RESIDENTIAL BUILDING PERMIT APPLICATION

MEMORANDUM

RE: 5628 Dosa Court, Potential Basement Bedroom

SEDIMENT AND EROSION CONTROL PLAN
THE WOODLANDS
 5628 DOSA COURT, LOT 3

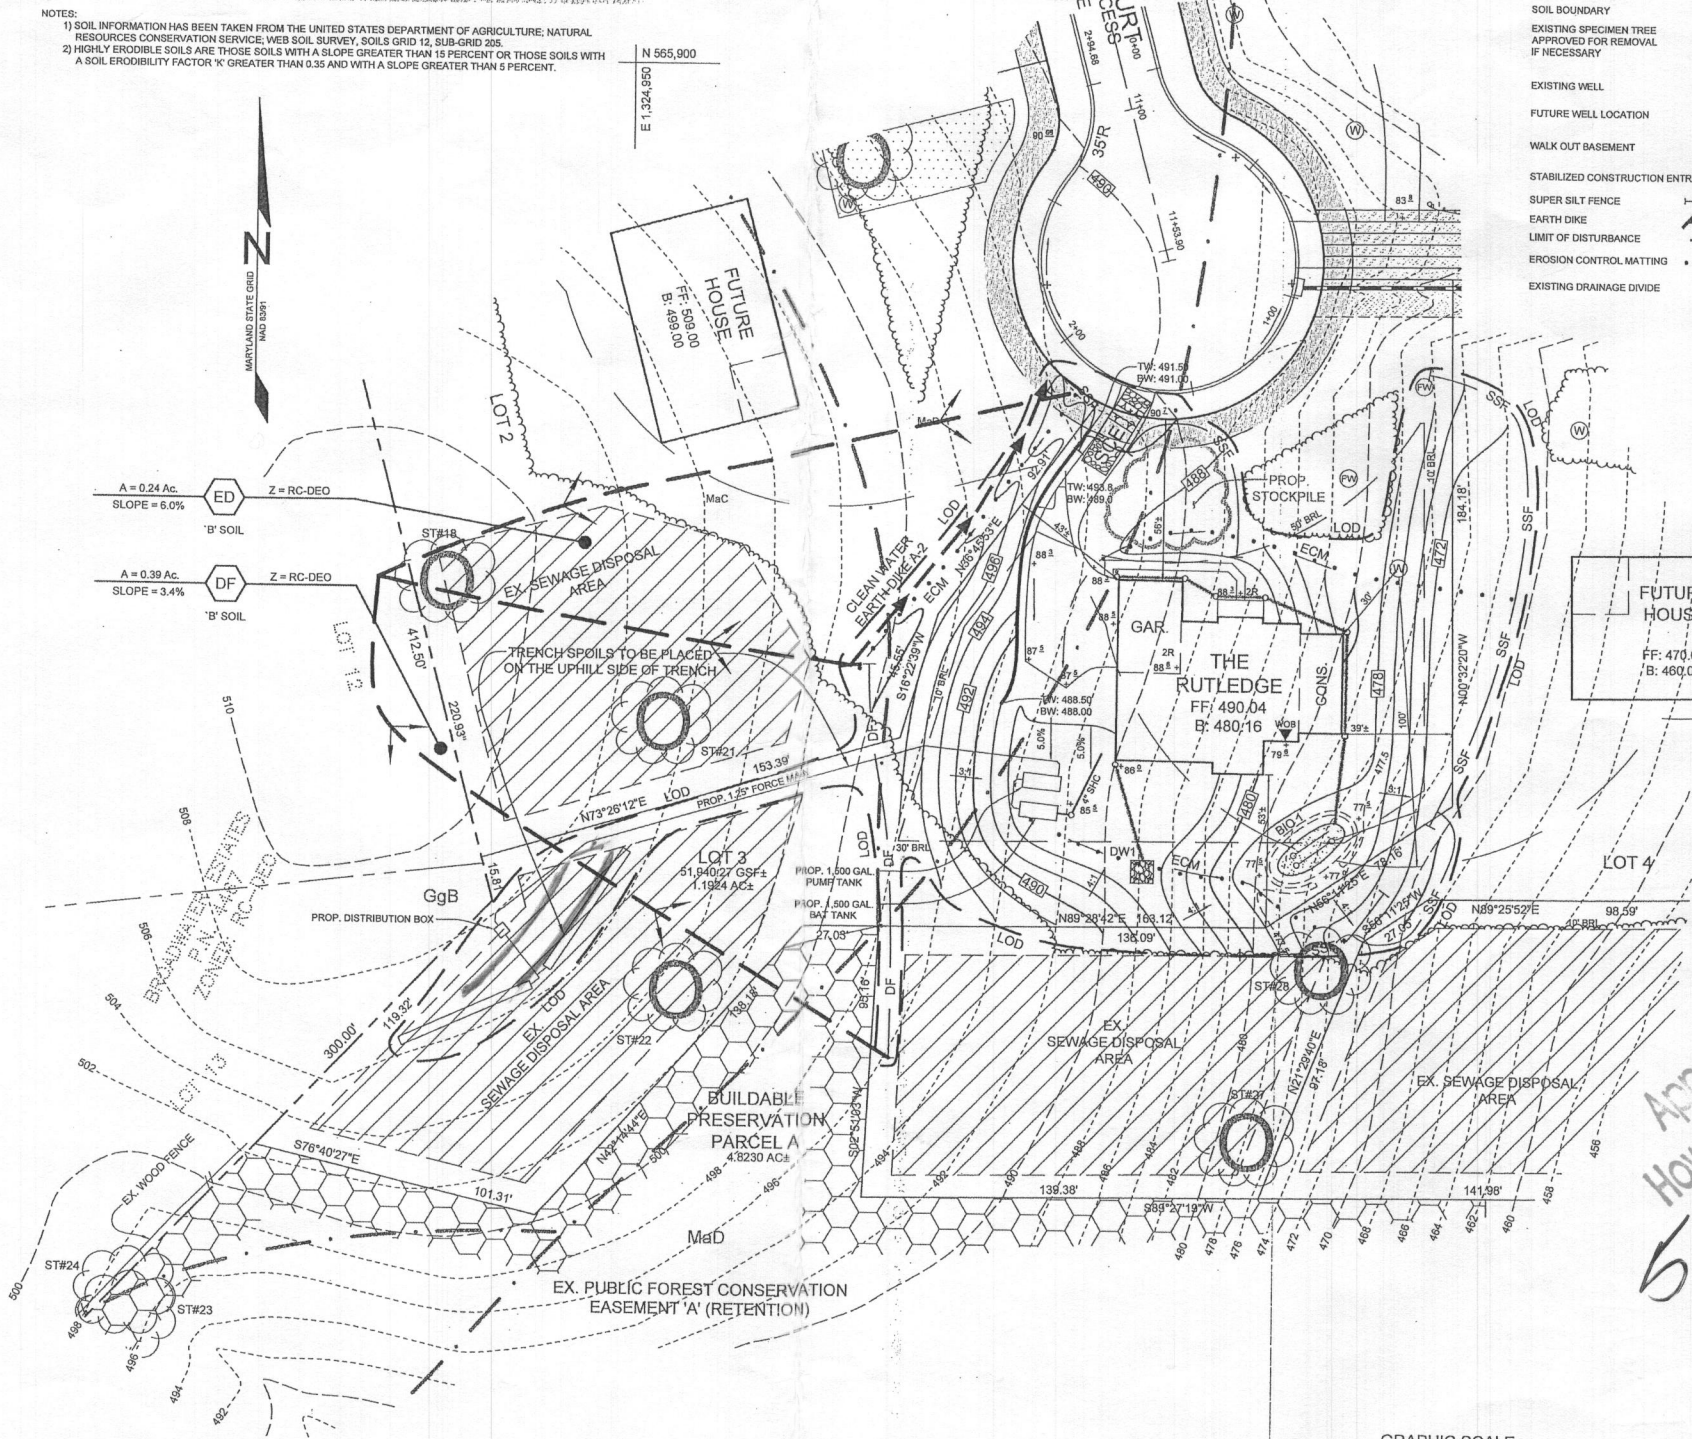
*Approved Septic System Plan
 Howard County Health Department
 5-Bedroom w/ Bath in Partly Finished Basement
 SFD approved
 5/19/2020
 Date
 Signature*

Drawing: BSMY/FOUNDATION PLAN
Project: WILLIAMSBURG GROUP
THE RUTLEDGE ESTATE HOME

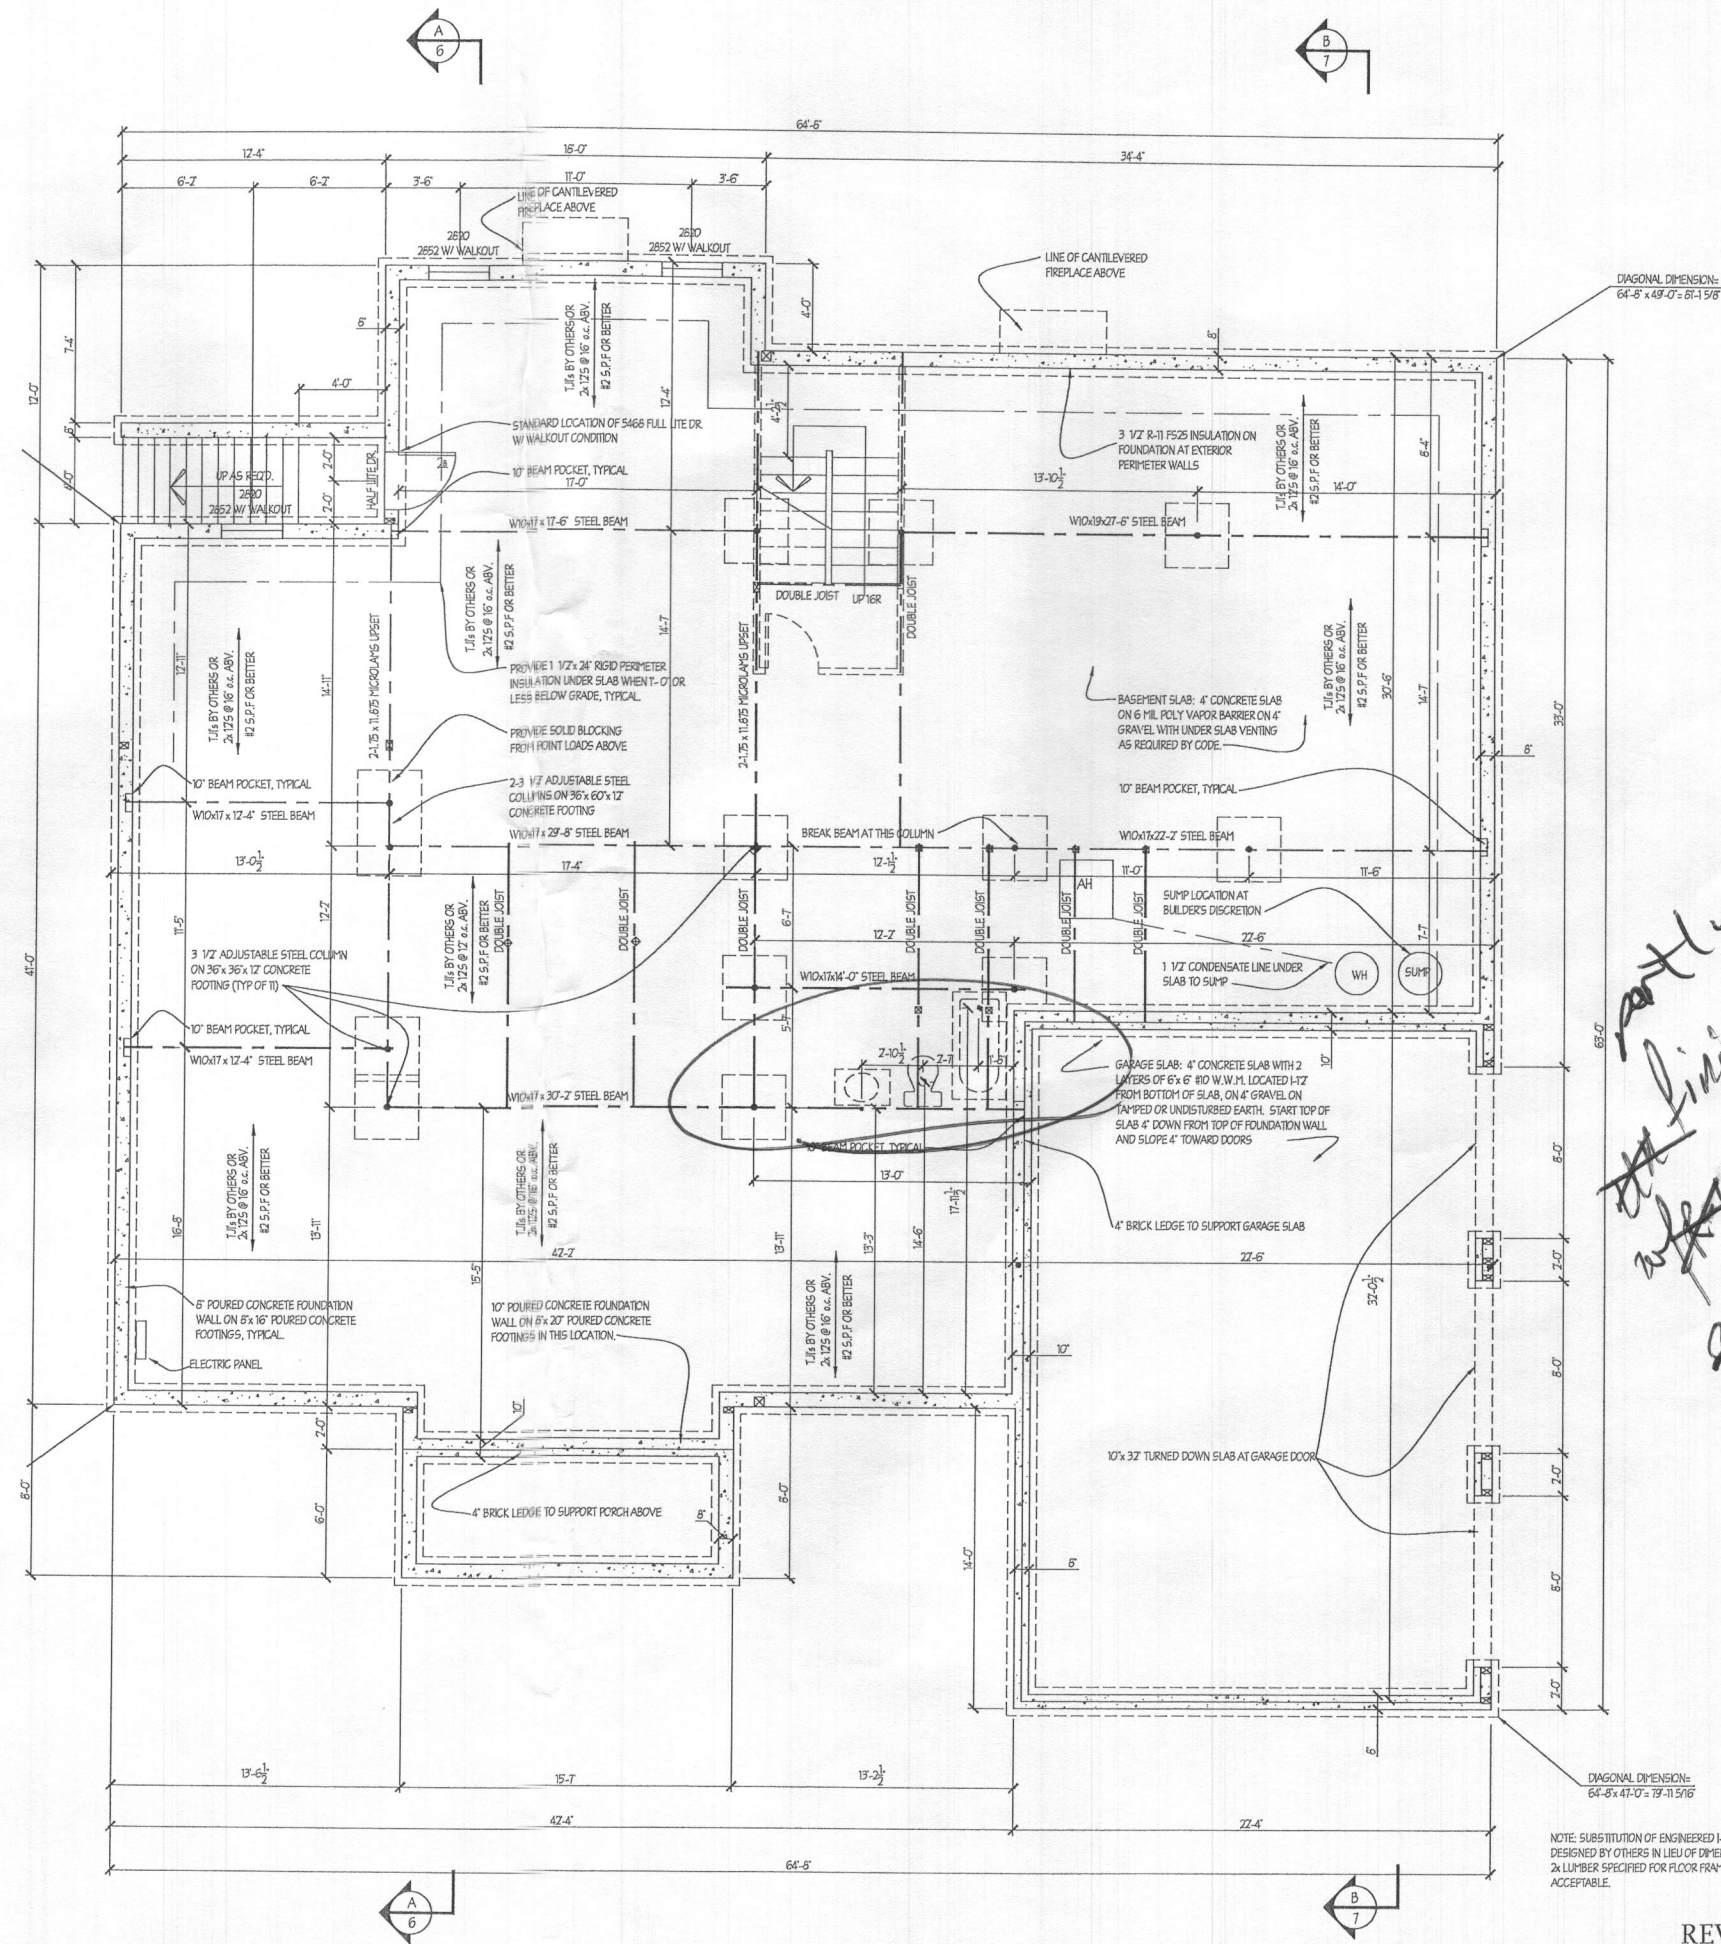
I have reviewed the floor plans in support of Building Permit B20001101 for a new home at 5628 Dosa Court and noted that there is a finished full bathroom in the partly finished basement. Please note that this makes it very likely for one or more rooms to be considered bedrooms upon further modification of the basement finished living space.

*partly
not finished basement
w/ bath
Send Memo*

The Health Department strongly recommends sizing the onsite sewage disposal system at least one bedroom larger than the existing five (5)-bedroom design to accommodate a future finished basement. If you choose to only size for the existing design, any future building permit for a finished basement may be placed on hold until the system is upgraded to accommodate the proposed number of bedrooms. This memo will be retained in the Health Department file for future reference.
